Decision Date: September 19, 2019

Re: VTT-82358-SL
10859 Hartsook Street
North Hollywood - Valley Village Plan Area
Zone : RD1.5-1
D.M. : 171-B-173
C.D. : 2 – Krekorian
CEQA: ENV-2018-5260-CE
Legal Description: Lot: 20; TR 8275

BUREAU OF ENGINEERING - SPECIFIC CONDITIONS

Date 08/10/2018
Scale 1" = 10'
Drawn SW
Job 18-177-002
Sheet 1 OF 1

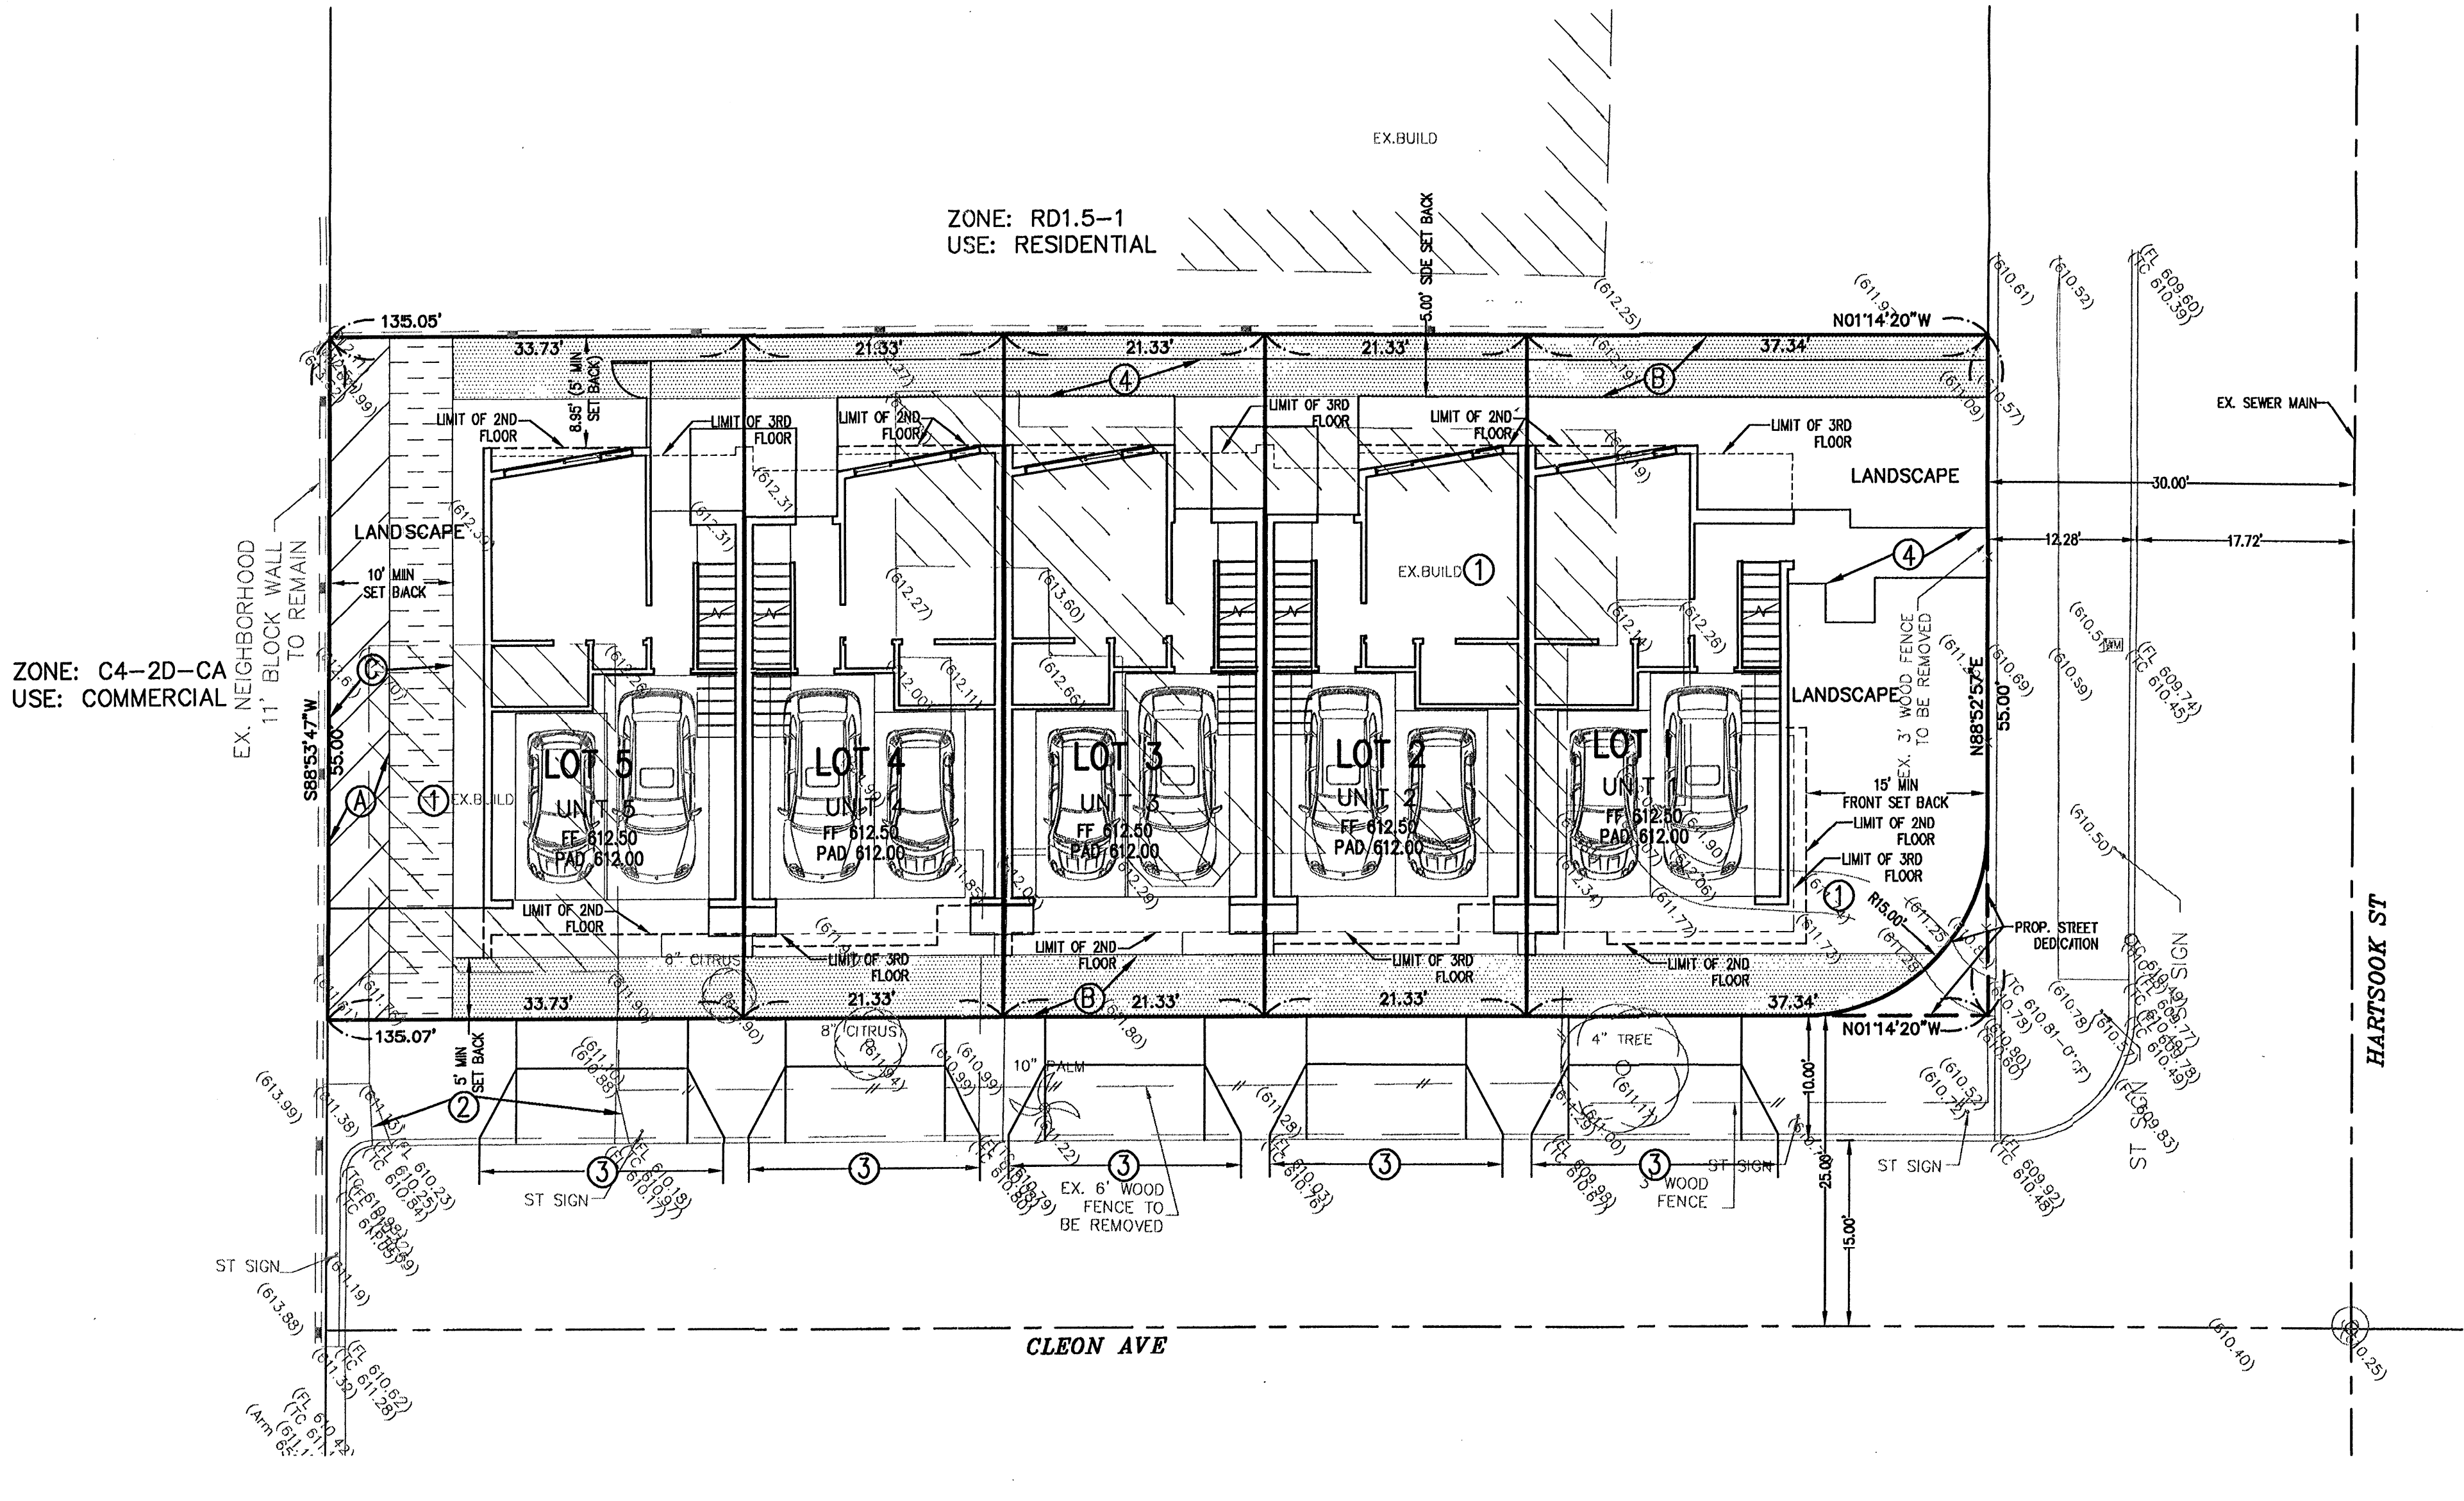
7. That prior to recordation of the final map, the Department of Building and Safety, Zoning Division shall certify that no Building or Zoning Code violations exist on the subject site. In addition, the following items shall be satisfied:
 - a. Obtain permits for the demolition or removal of all existing structures on the site. Accessory structures and uses are not permitted to remain on lots without a main structure or use. Provide copies of the demolition permits and signed inspection cards to show completion of the demolition work.
 - b. Show all street dedication(s) as required by Bureau of Engineering and provide net lot area after all dedication. "Area" requirements shall be re-checked as per net lot

area after street dedication. Front and side yard requirements shall be required to comply with current code as measured from new property lines after dedication(s).

- c. The submitted map does not comply with the maximum density (1,500 s.f. of lot area/dwelling unit) requirement of the RD1.5-1 Zone. Revise the map to show compliance with the above requirement based on the lot area after required street dedication is taken or obtain approval from the Department of City Planning.
- d. Provide and dimension the reciprocal private easement for pedestrian and driveway egress and ingress in the final map.

The submitted Map may not comply with the number of guest parking spaces required by the Advisory Agency.

The proposed buildings may not comply with City of Los Angeles Building Code requirements concerning exterior wall, protection of openings and exit requirements with respect to the proposed and existing property lines. Compliance shall be to the satisfactory of LADBS at the time of plan check.

Backup space for parking space with less than 26'-8" shall provide sufficient parking stall width and garage door opening width to comply with the current Zoning Code requirement. Comply with the above requirement at the time of Plan Check or obtain City Planning approval.
